Corrections of Hardware Manual

MB90540 -

HM90540_add_V100

Addendum, MB90540 Hardware Manual (CM44-10108-2E)

MB90F54X, MB9054X: power-on pin-state behaviour

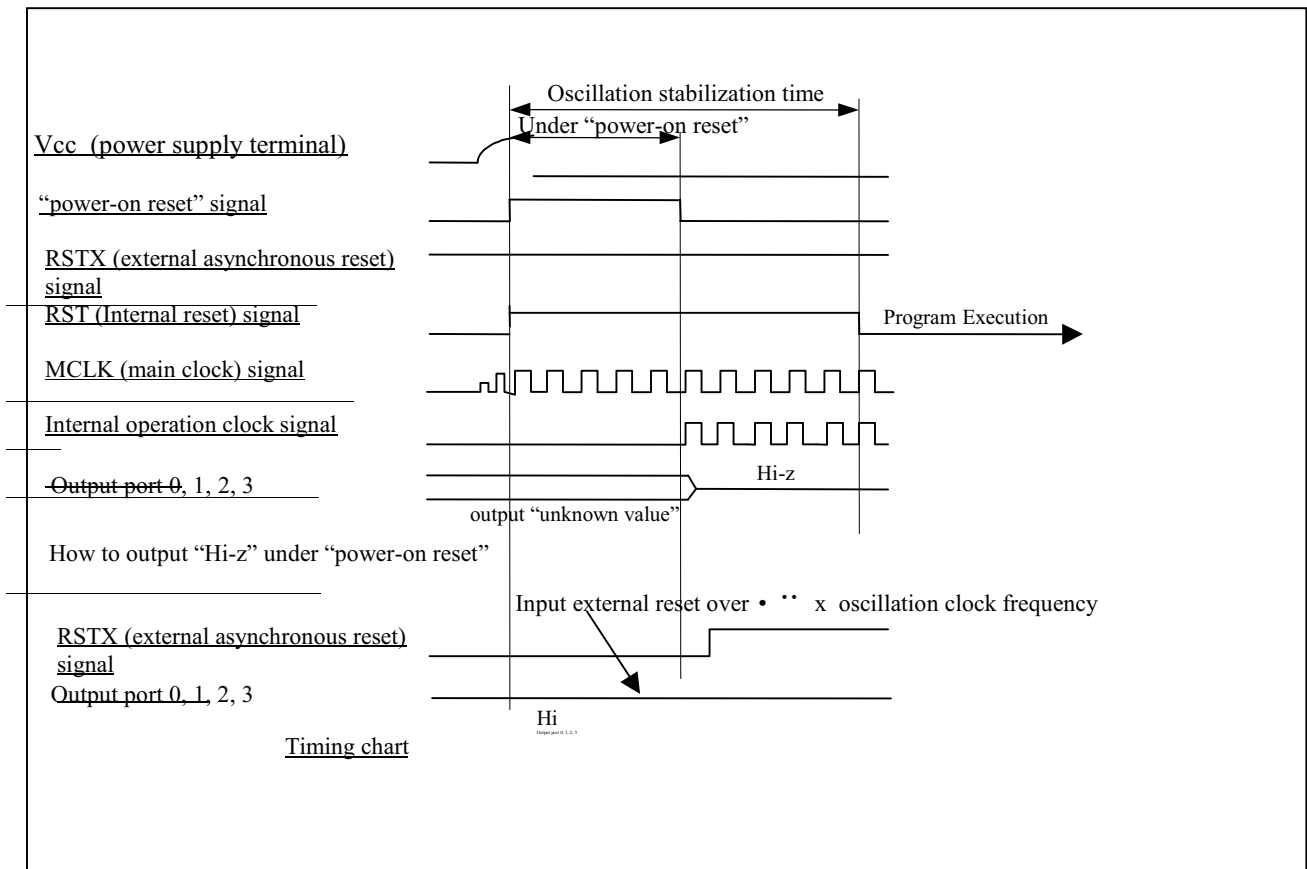
Conditions:

Mode pins = 011 (single chip mode), RSTX and HSTX = 1 during power-on

P00 to P37 = "X" (external bus)

P46, P47 = "X" (Serial IO outputs)

P76 to P84 = "X" (PPG, Output compare)

all other ports "Z"

P means Port, not pin. "X" can be anything (high, low, Z)

Asserting RSTX instantly sets all ports to "Z", even if the oscillation didn't start yet.

If RSTX is NOT asserted, the ports mentioned above remain "X" until the end of the power on reset time which is 2^{17} oscillation cycles (32ms for 4MHz crystal). At the end of this time, the internal clock starts and ALL ports will be set to "Z".
